UNITED STATES PATENT AND TRADEMARK OFFICE

Office Action Summary

10/619,017

DETAILED ACTION

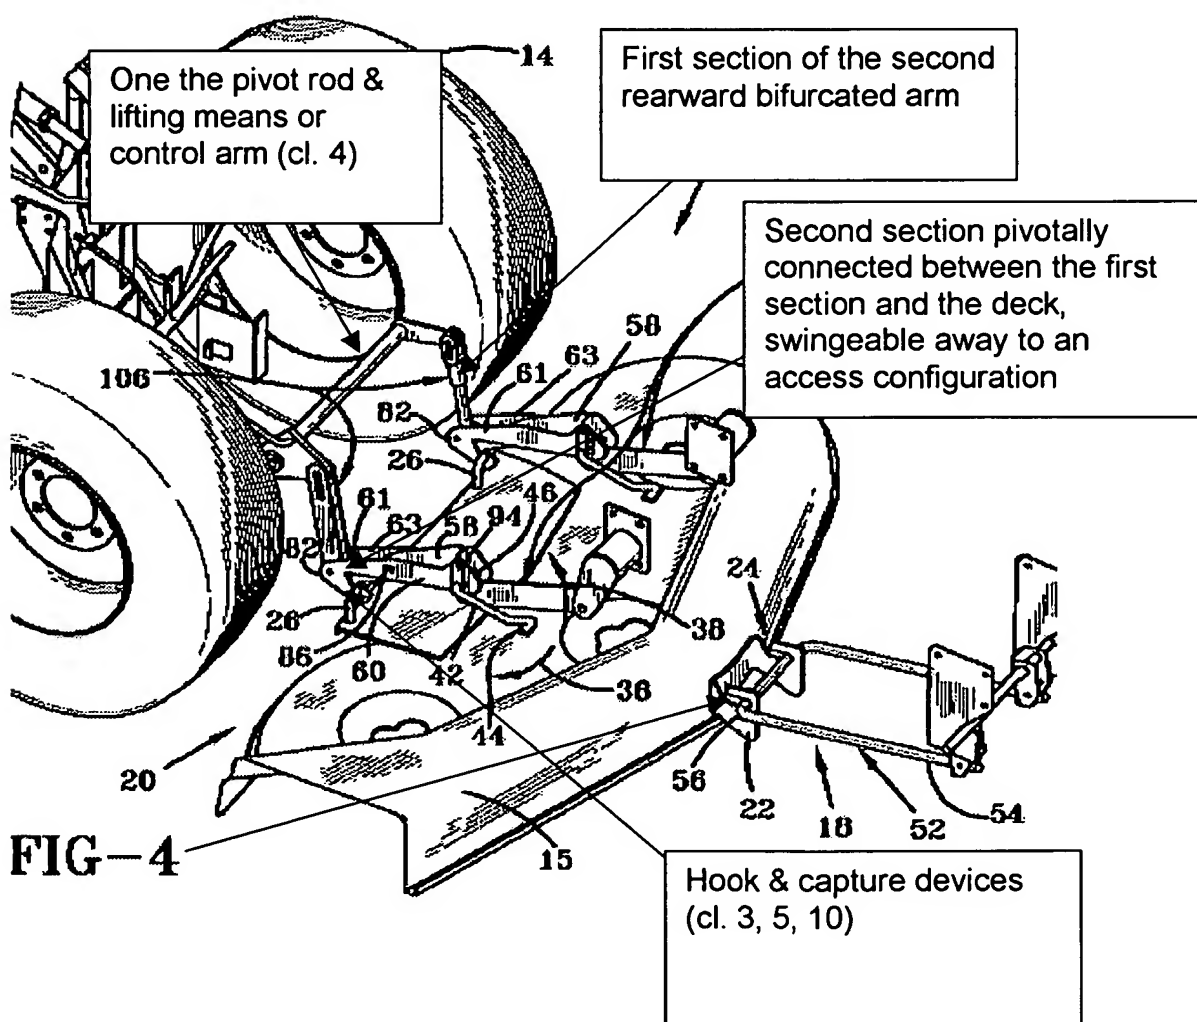
1. Claims 1, 12 are objected to because of the following informalities: since "at least one rear wheel" recited in ¶ a, in ¶ b "rear wheels" should be – at least one rear wheel – (claim 1); "said position stop" should be – a position stop – (cl. 12). Appropriate correction is required.

in re claim 1:

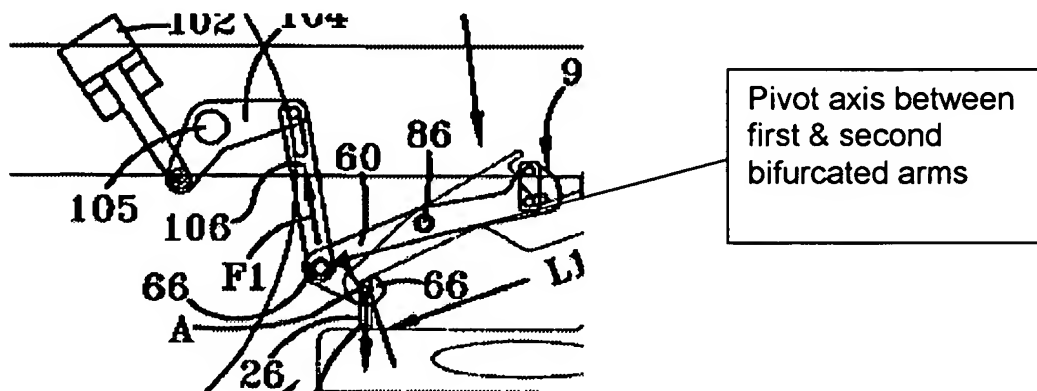
the first section of the bifurcated arm (fig 4, ref 106) pivotally mounted on said frame (fig 2, ref 12);

the first & second sections are pivotally connected (106 & 58 pivot as shown bellow):

the "first section ... abuts against the frame," although, the Examiner disagrees with Applicant's contention, however, aforementioned phrase is not found in claim 1, instead the following phrase is recited & met by Plas as shown in detailed rejection above: "the first section of the bifurcated arm pivotally mounted on said frame."

Applicant's argument that the functional/intended use statement is not capable with Pas' bifurcated arm is not agreed with, since as shown in the above detailed rejection there is at least one pivot location enabling the aforementioned function.

in re claim 2:

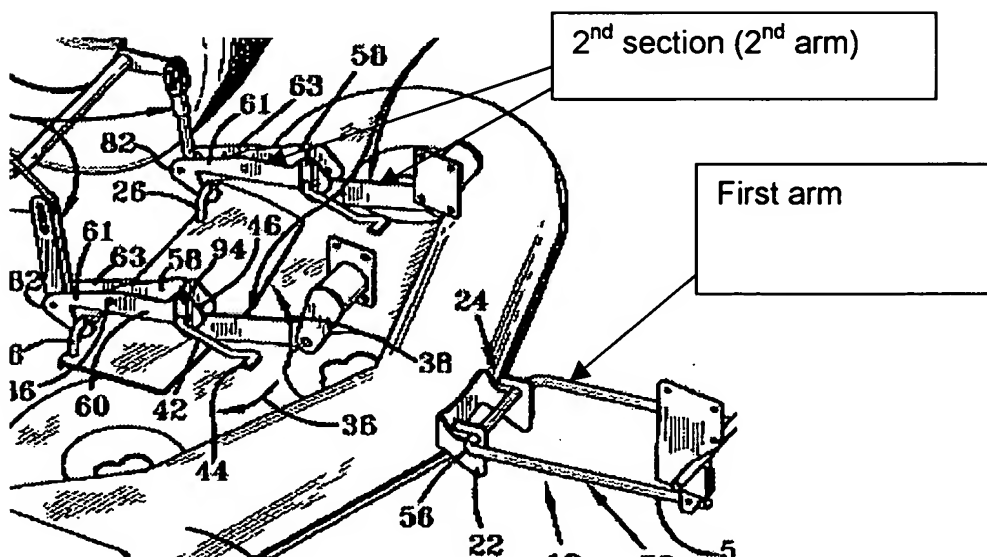
the arms form a generally parallelogram configuration (see fig 2), also:

It is unclear how the "generally parallelogram configuration" is not met by Plas. The Examiner further detailed above in the hopes of reinforcing earlier Examiner's earlier rejection.

in re claims 6, 10, 12:

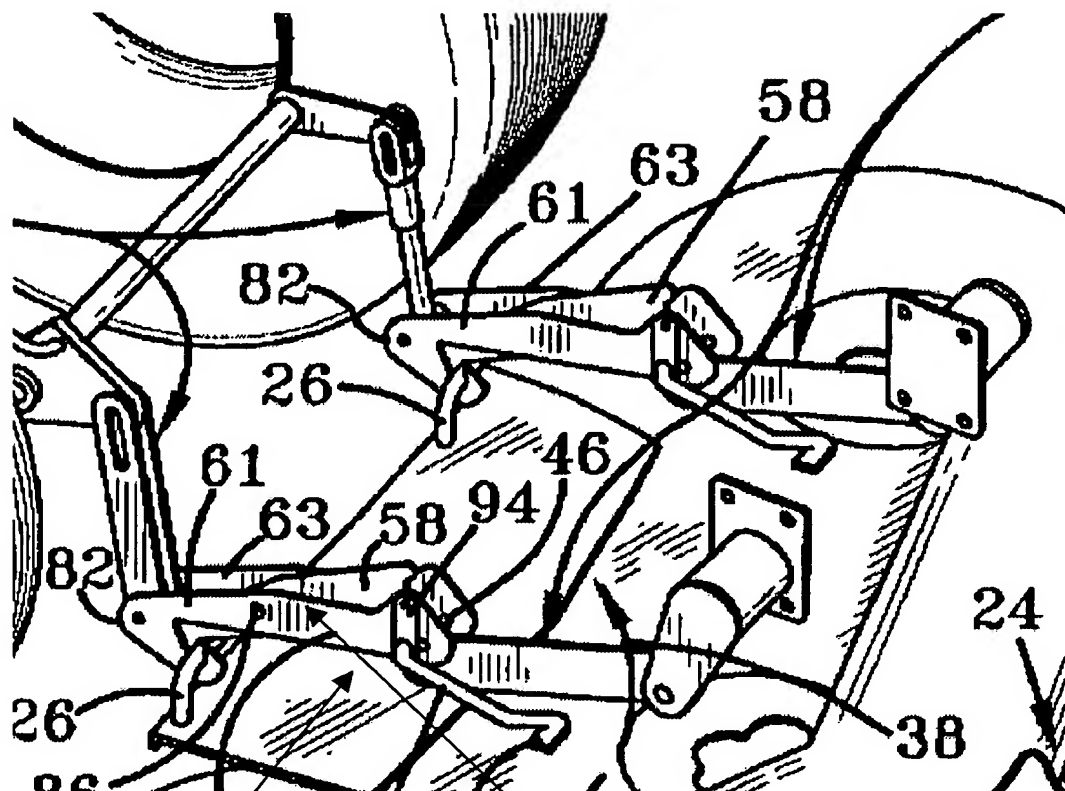
Stop includes a pin

Stop arm

Applicant appears to argue that claims 10-16 include a structure not shown by Plas, namely a stop pin, however only claim 12 recites: "stop arm ... position stop includes a pin" which is met by Plas as further detailed above.

in re claims 8, 20:

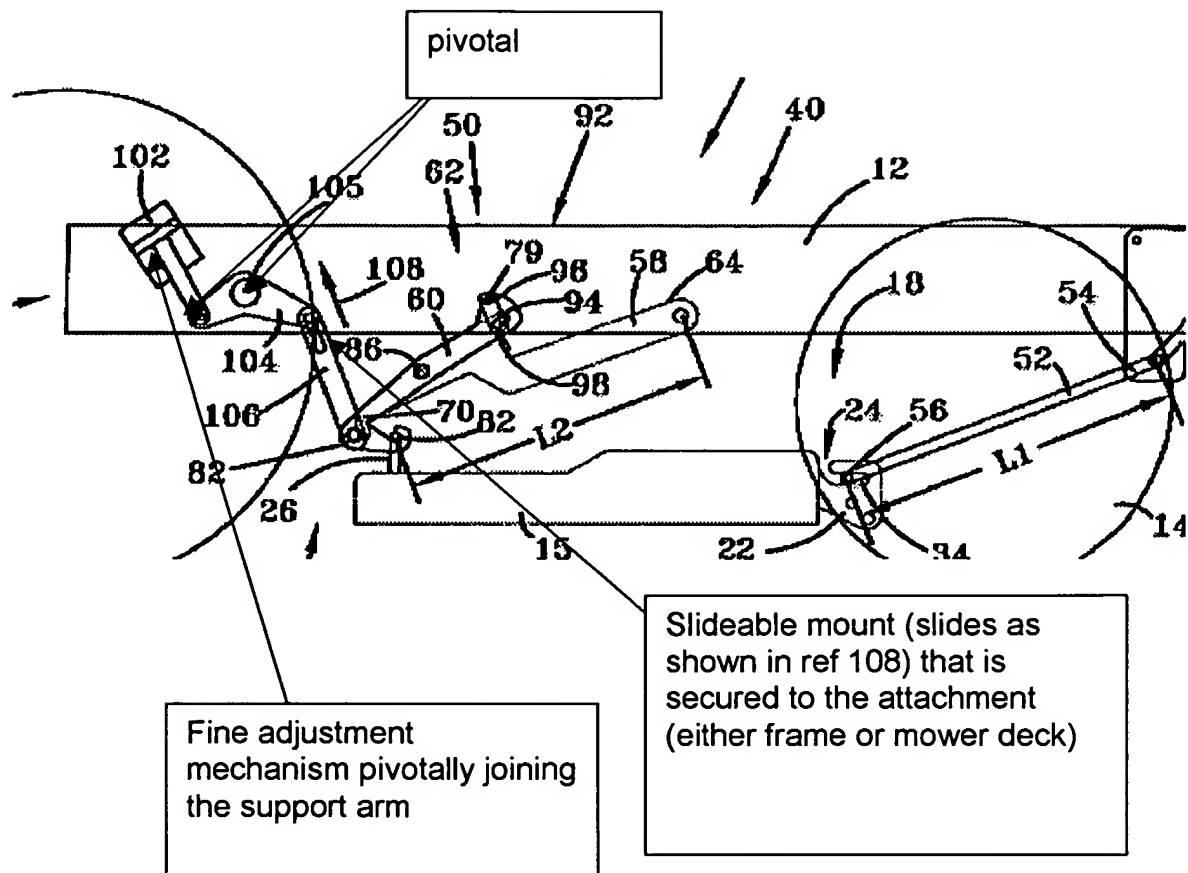
Applicant refers to Applicant's figure to point to referenced structures not shown, however the claim language of claims 20-27 should be pointed out which differ from Plas, which is shown in greater detail above. It is noted that some of the basic structure already provided for in re earlier claims.

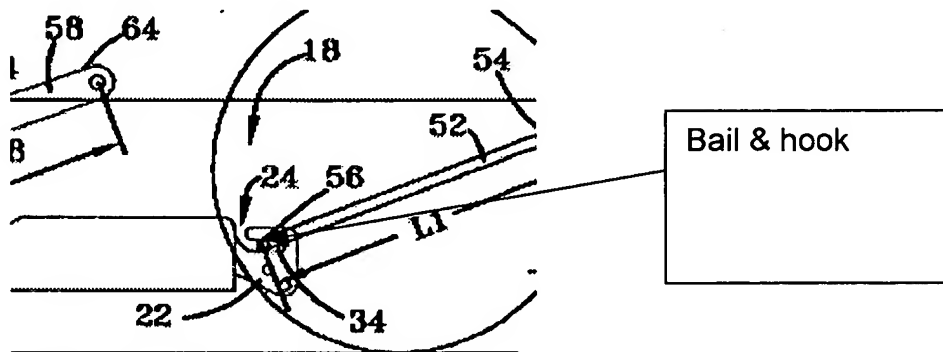
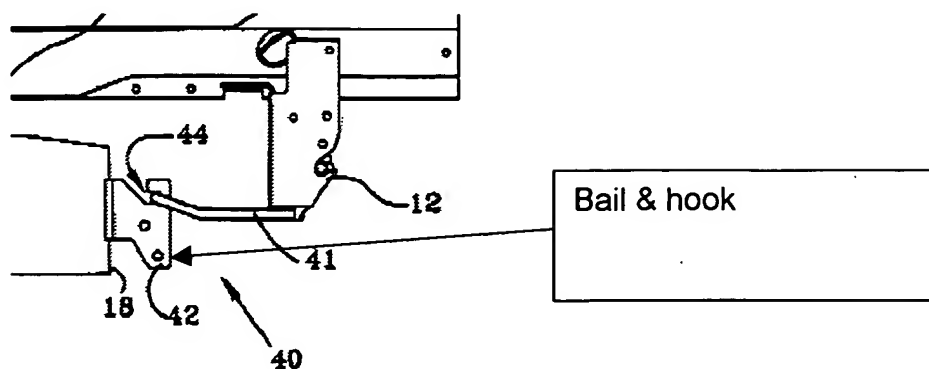
Plas or Schmidt prior art discloses the claimed invention except for arranging the hook & bail in reverse order (cl. 28).

Plas shows the bail/hook arrangement:

Schmidt shows the bail/hook arrangement:

It would have been obvious to one having ordinary skill in the art at the time the invention was made to arrange the hook & bail reversely as claimed, since it has been held that a mere reversal of the essential working parts of a device involves only routine skill in the art. *In re Einstein*, 8 USPQ 167.

Examiner reviewed Applicant's amendment, however did not find that it would overcome Plas and/or Schmidt, since the deck is pivotally joined to the frame, and the functional/intended use statement is capable to be performed by either Plas or Schmidt, i.e. the "to allow said deck to pivot and rotate ... relative to said frame." The bail & hook arrangement of Plas & Schmidt is for unhooking the mower, and it does not require complete disassembly as argued by the Applicant.
